Byron Station, Units 1 and 2
Facility Operating License Nos. NPF-37 and NPF-66
NRC Docket Nos. STN 50-454 and STN 50-455

Subject: Initial License Examinations Post-Examination Review

**Byron Station Staff/Applicant Comments
Regarding the NRC Initial Written Examination**

FIGURE HT-7-22c RCP B TRIP MANUAL RODS

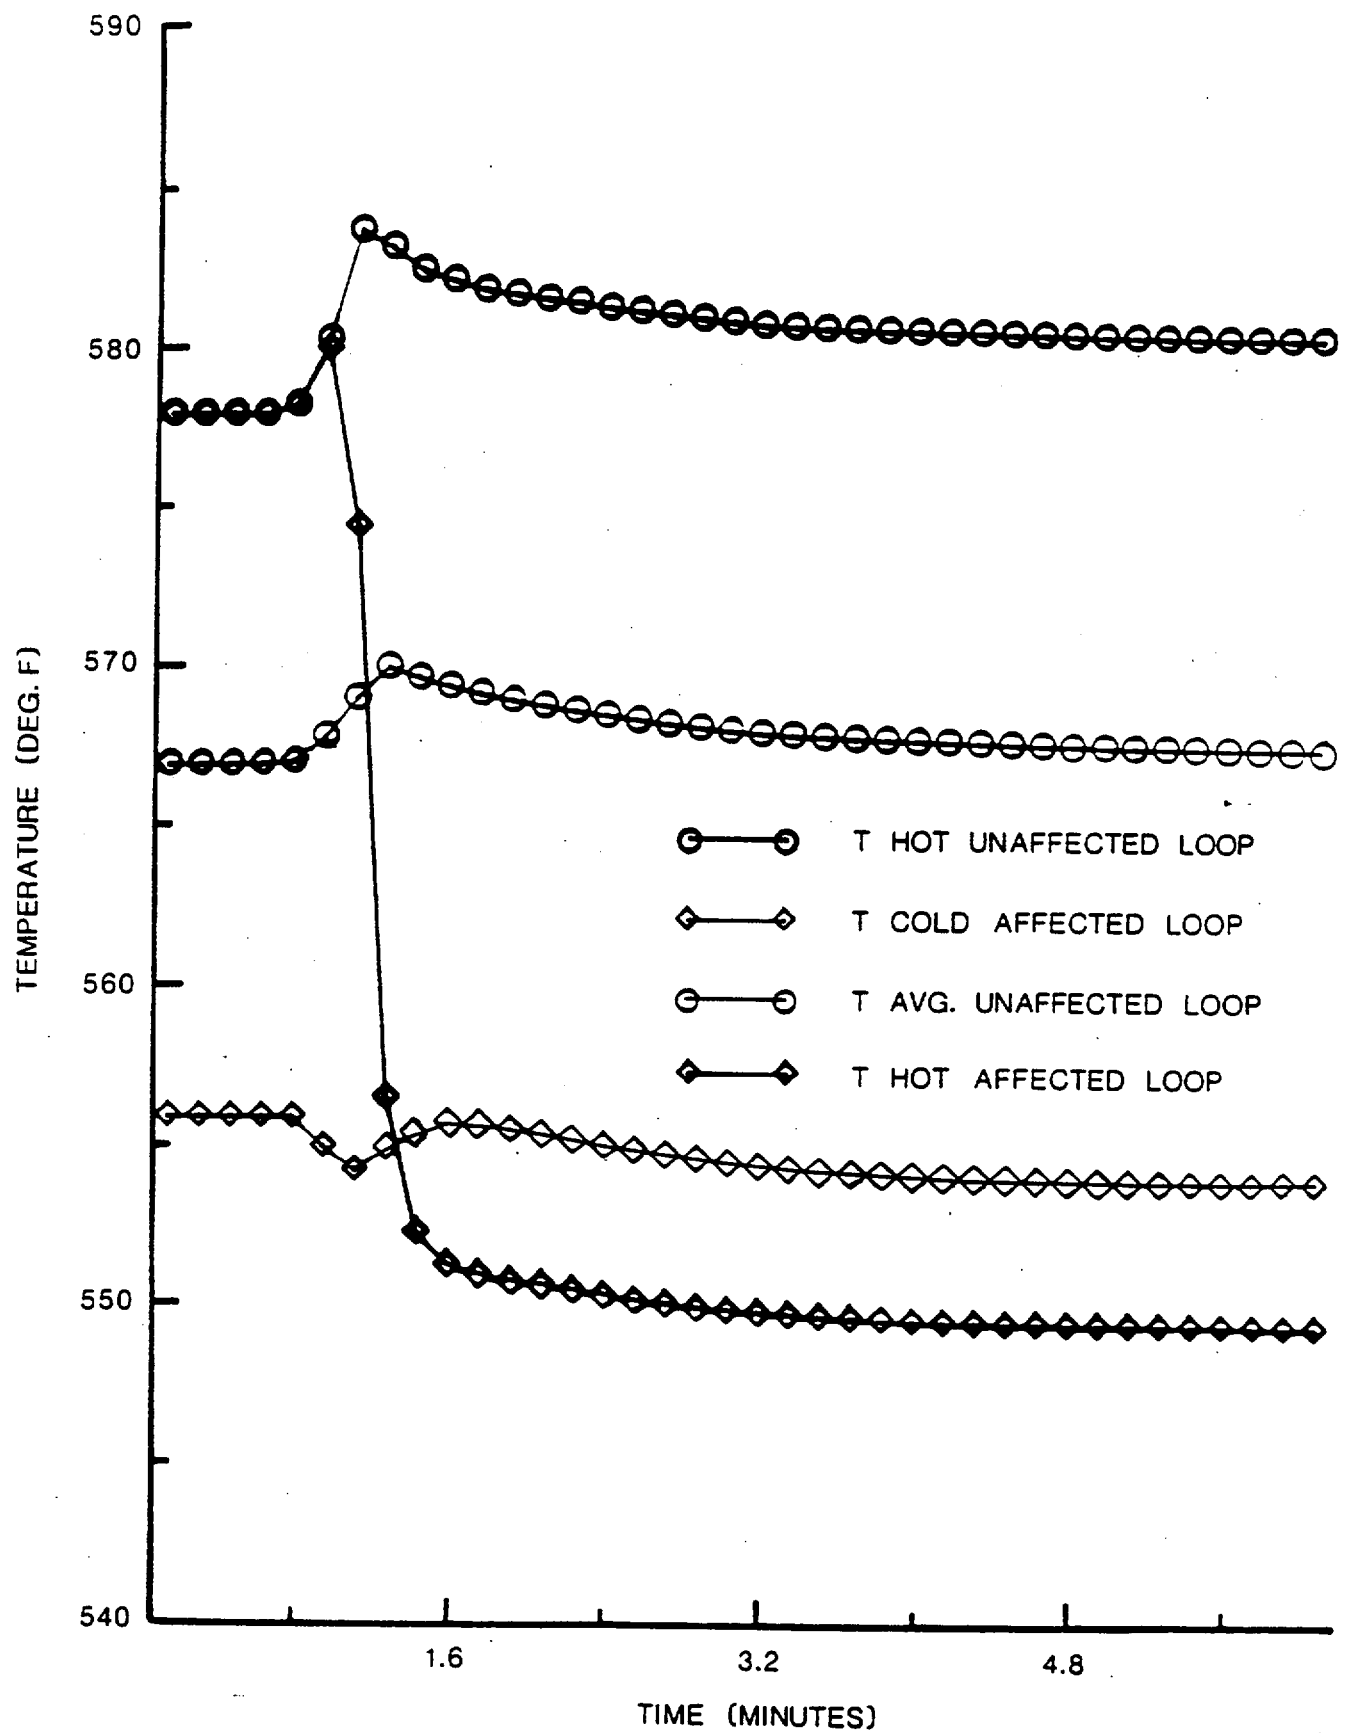
Comment: Distractor D is the correct answer for this question. The question asks for the initial response of the unit due to a trip of a reactor coolant pump. Hot leg temperature in the unaffected loops will increase since the same reactor heat input is being absorbed by less total core flow. This causes Tavg to initially increase.

Resolution: Accept distractor D as the only correct answer.
